Monitoring Report
FINAL VERSION
Horne Creek Tributaries Mitigation Project
Monitoring Year 1
Calendar Year of Data Collection: 2020

NCDEQ DMS Project Identification # 100026
NCDEQ DMS Contract # 7181
Yadkin River Basin (Cataloging Unit 03040101)
USACE Action ID Number: SAW-2017-01510
NCDEQ DWR Project # 2017-1156
Surry County, NC
Contracted Under RFP # 16-006993
Data Collection Period: November 2020
Submission Date: December 2020

RE: WLS Responses to NCDEQ DMS Review Comments for Task 7 Submittal, Monitoring Year 1 Report for the Horne Creek Tributaries Mitigation Project, DMS Full-Delivery Project ID #100026, Contract #7181, Yadkin River Basin, Cataloging Unit 03040101, Surry County, NC

FIGURE
1b

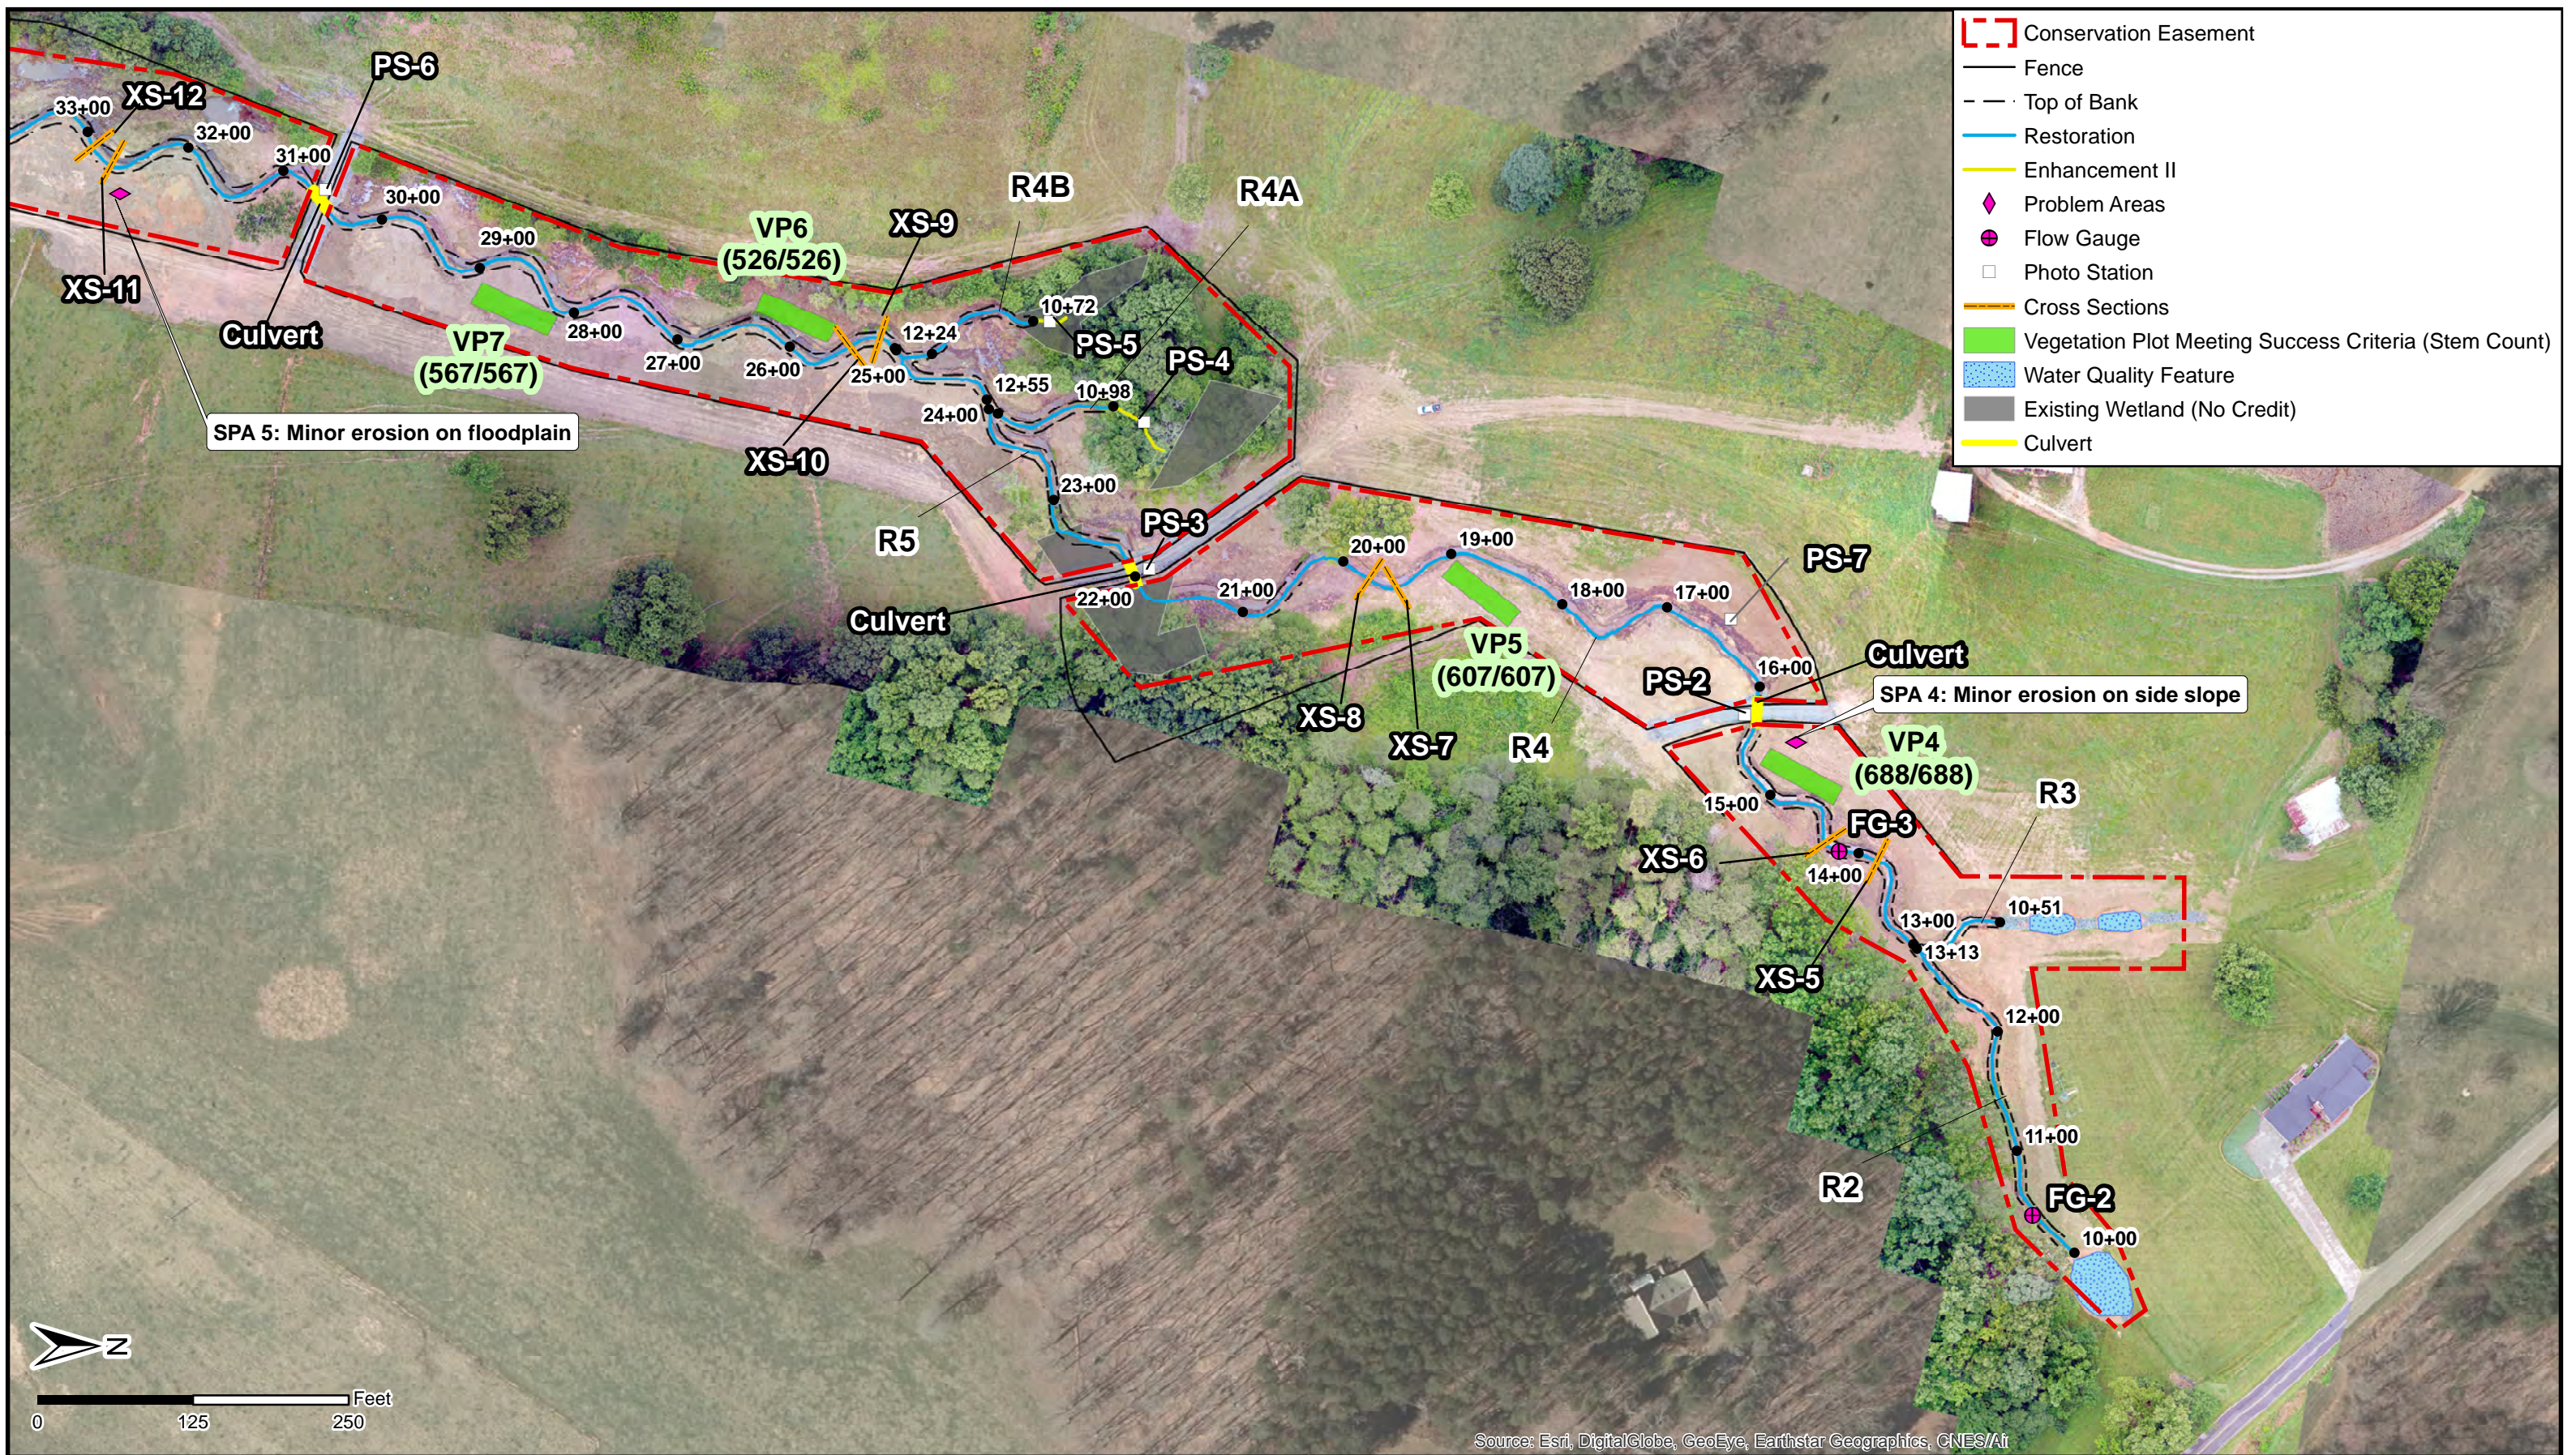
- **CCPV: The conservation easement is not showing correctly on the R4 section on Sheet 1b. Please update.** WLS Response: The conservation easement boundary is now showing correctly on Sheet 1b.

Project Name	Horne Creek Tributaries Mitigation Project
Project ID	100026
Reach ID	R4
Cross Section ID	XS-6
Field Crew	K. Obermiller, E. Dunnigan

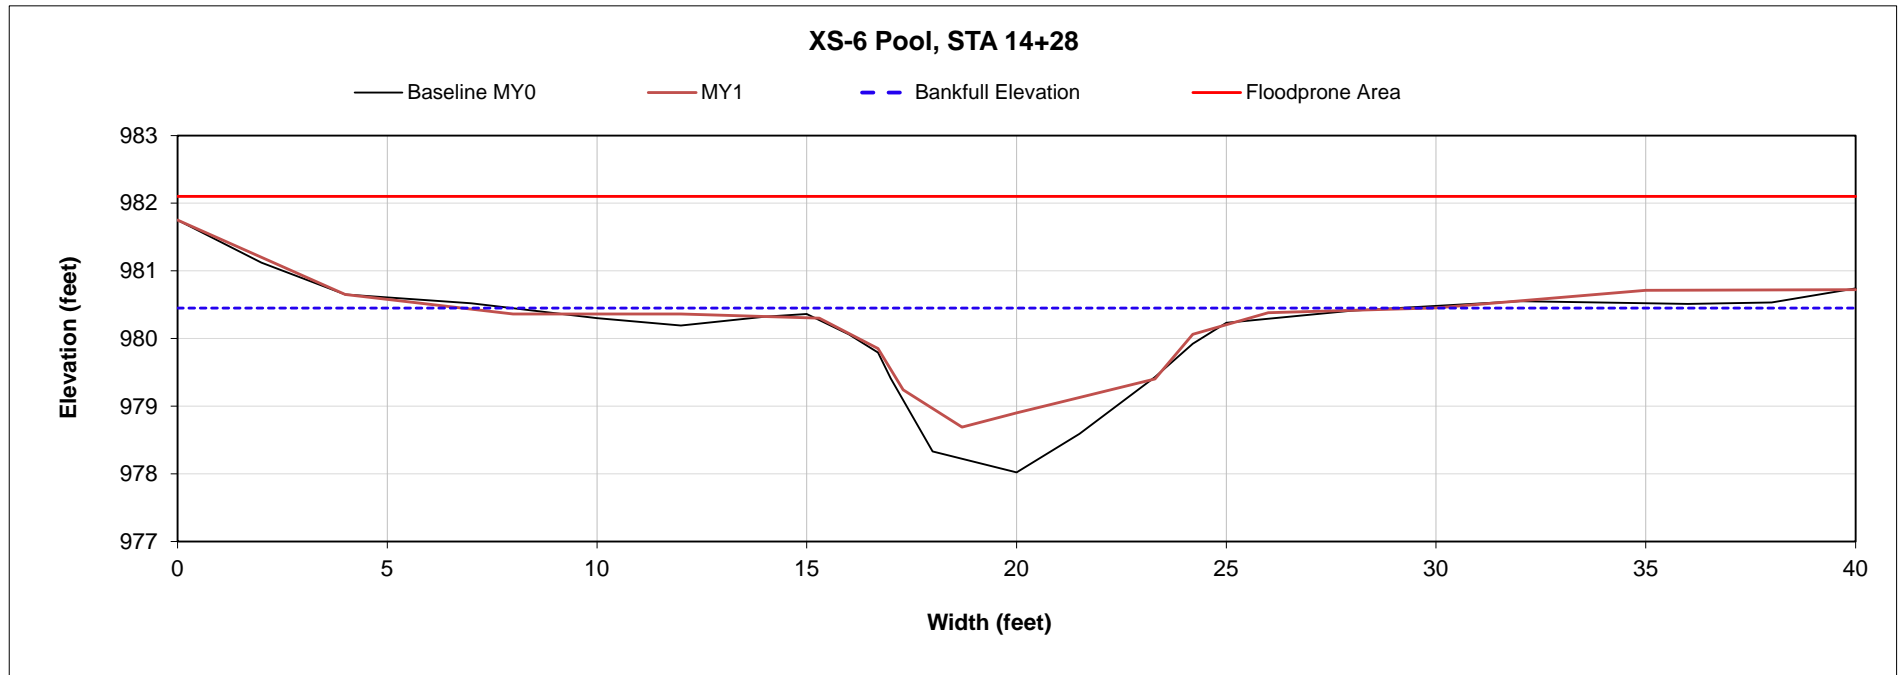
- **Pool cross-section graphs (XS-6, XS-7 and XS-11) indicate aggradation. Is the amount of aggradation within the tolerances WLS would expect to see at this point in the project history? Please continue to monitor and observe changes in MY2.** WLS Response: The amount of aggradation observed is within tolerances expected, given the high rainfall totals measured during MY1. Visual surveys indicate the areas affected are functioning and stable. WLS will continue to monitor and note any changes in the MY2 report.

Horne Creek Tribs - Crest Gauge CG-2 (R5)

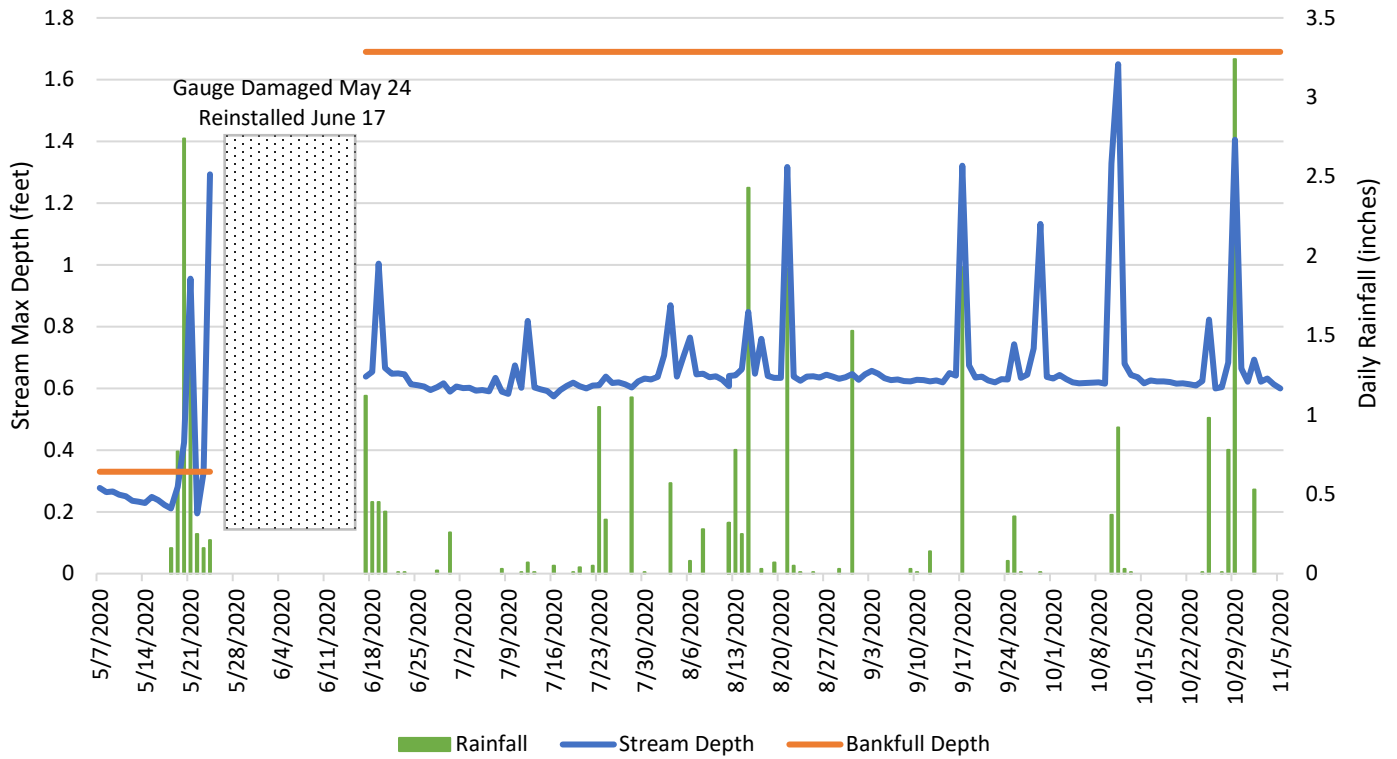
- **3.22 Bankfull Events: CG-2 recorded two events during MY1. The two events were recorded prior to the gauge being damaged and moved. The new reinstalled location has a new bankfull depth as shown on Figure 4. The new location did not record a bankfull event despite several 2.5-3" rain events. Is WLS confident that the location and calibration of CG- 2 is capturing bankfull events in the new location?** WLS Response: WLS is confident in the location of CG-2. WLS re-surveyed CG-2 on December 7th, 2020 and adjusted the re-installed bankfull height to 1.69'. Since the submittal of the draft monitoring report, CG-2 has recorded a bankfull event. Figure 4 in Appendix E has been updated with the corrected bankfull depth of 1.69'.

** CG-2 was re-surveyed in its new location after reinstallation with new bankfull depth of 1.69'
